# AKH ECO APPARELS LTD.

495-Balithia, Shah-Belishwer, Dhamrai, Dhaka  
(23.9166 N, 90.1136 E)  
18<sup>th</sup> October 2015

# Observations

Typical floor plan

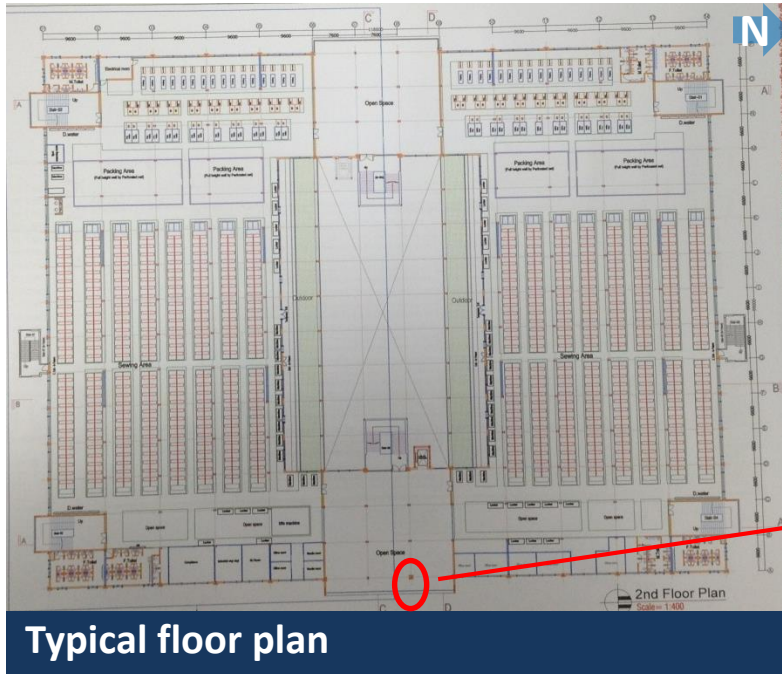
Connection of cantilevers at stair appear light

5 mm stiffener

Top of connection is open

Connections of cantilevers on floor plate at  
level 4 appear light

Various depth of beam on each side of column

Connections between cantilevers on floor plate at level 2 appear light

Item No.	Observation	Recommended Action Plan	Recommended Timeline
1	Connection of cantilever beams at stair appear light, particularly the stiffener	Building Engineer to review design of the cantilever beam/column connection. It is also noted that the top of the cantilever connection is not fully tightened	6-weeks
2	Connection of cantilever beams at stair appear light, particularly the stiffener	Building Engineer to review design of the cantilever beam/column connection. It is also noted that the top of the cantilever connection is not fully tightened	6-months
3	Connections of cantilevers on floor plate at level 4 appear light. Note lack of deep back span beam	Building Engineer to review design of the cantilever beam/column connection. There is a lighter beam forming the back span It is also noted that the top of the cantilever connection is not fully tightened	6-weeks
4	Connections of cantilevers on floor plate at level 4 appear light. Note lack of deep back span beam	Carry out any remedial action as a result of the connection review. Alter connection to avoid gap between end plate and column flange	6-months

**Typical Roof Plan**

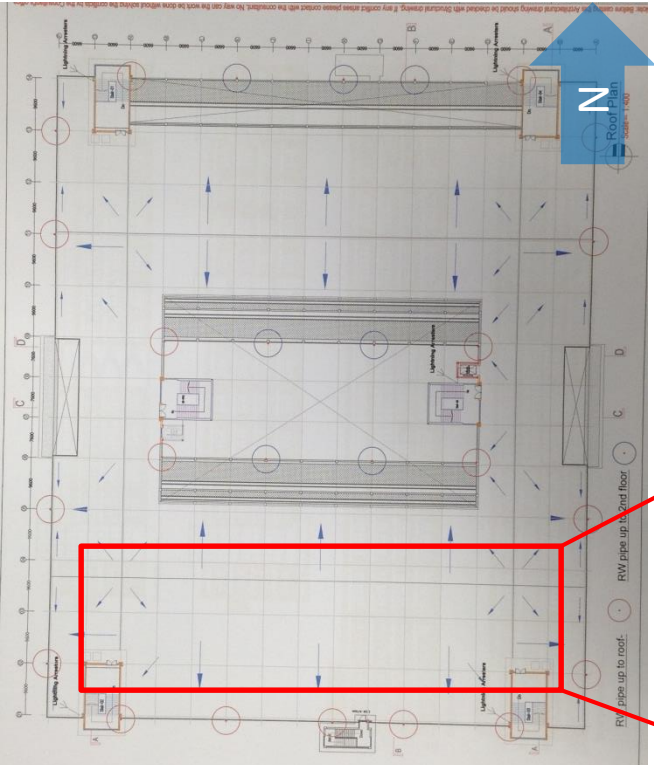
Open connections noted throughout the building

Column stubs noted on roof at southern end

**Column stubs noted on roof at southern end. Any proposed additions to the existing building structure, including additional storeys, should be reviewed by the Building Engineer**

<b>Item No.</b>	<b>Observation</b>	<b>Recommended Action Plan</b>	<b>Recommended Timeline</b>
5	Open connections noted throughout the building	Building Engineer inspect and snag all connections and agree remedial actions.	<b>6-weeks</b>
6	Open connections noted throughout the building	Carry out remedial actions to open connections.	<b>6-months</b>
7	Column stubs noted on roof at southern end	Any proposed additions to the existing building structure, including additional storeys, should be reviewed by the Building Engineer.	<b>6-weeks</b>
8	Loading bay column not protected from traffic collision	Building engineer to review column in loading bay and its vulnerability to a collision by a truck.	<b>6-weeks</b>
9	Loading bay column not protected from traffic collision	Install protective measures following from above review	<b>6-months</b>
10	Rubble and water tanks temporary noted on roof.	Building engineer to review loading from 5000litres tanks on roof. (advised tanks were temporary as pumps were yet to be installed for underground tank)	<b>6-weeks</b>

Typical Ground Floor Plan

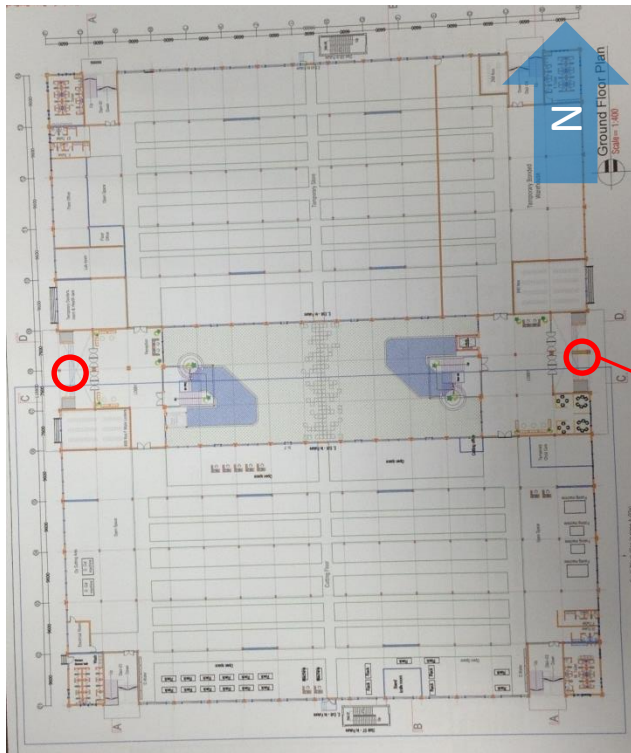
Loading bay column not protected from traffic collision

Typical Roof Plan

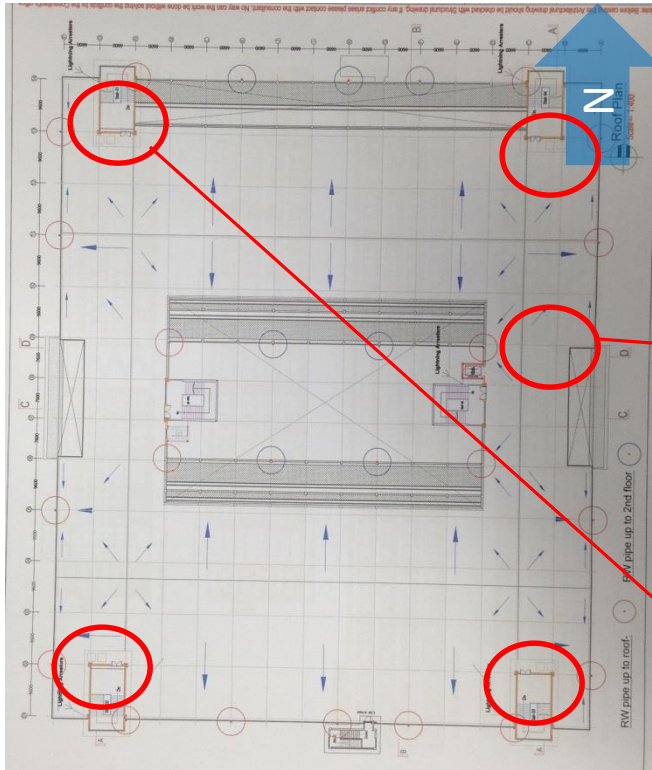
Rubble and water tanks noted on roof

Rubble and water tanks noted on roof.

11	Rubble and water tanks temporary noted on roof.	Rubble to be removed from roof. Remove temporary tanks if required by above review	<b>6-months</b>
